Winmore Townhomes

Town Council Presentation

CHAPEL HILL HIGH SCHOOL April 18, 2018

Solutions incorporated into the design

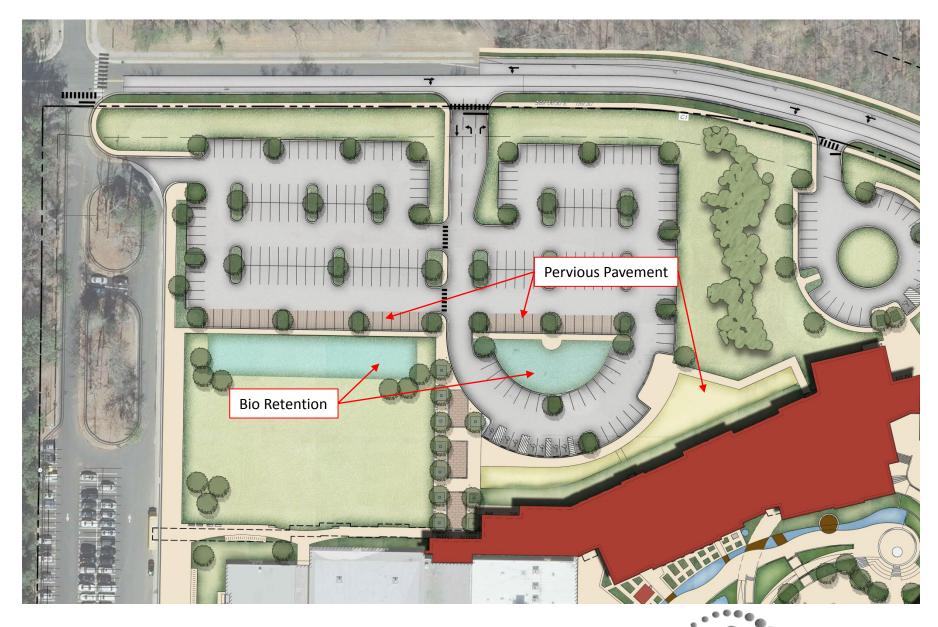
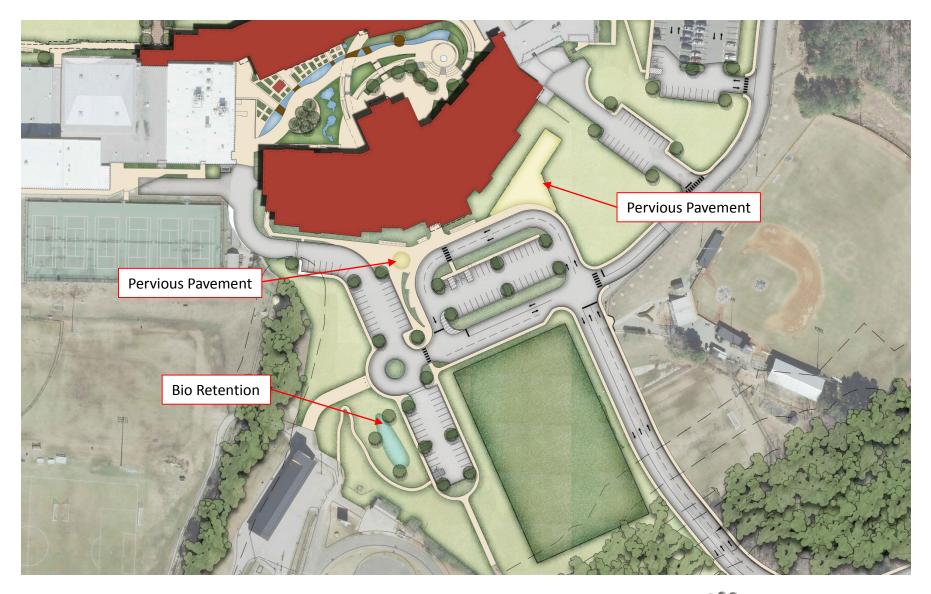
- Bio Retention ponds that drain parking lot water
- Harvest Rainwater from roof of new building in above ground cisterns
- Employ careful re-sloping of the old athletic field East of the new road to slow stormwater flow and reduce erosion in to Jolly Branch

- Include one half acre of pervious pavement in the parking lot
- Use Native plantings and trees wherever possible
- Widening of the entrance road off of Seawell School Rd. should be done on the opposite side from Jolly Branch so construction can stay out of the managed watershed area

- Reduction in impervious surface approximately 1.5 acre
- Bioretention Student Parking (approximately 2.5 acre)
- Pervious Pavement / Infiltration Parking & Fire Lanes (approximately 1/2 acre)

- Educational Courtyard
  - Cistern
  - Rain Garden
  - Stormwater Detention
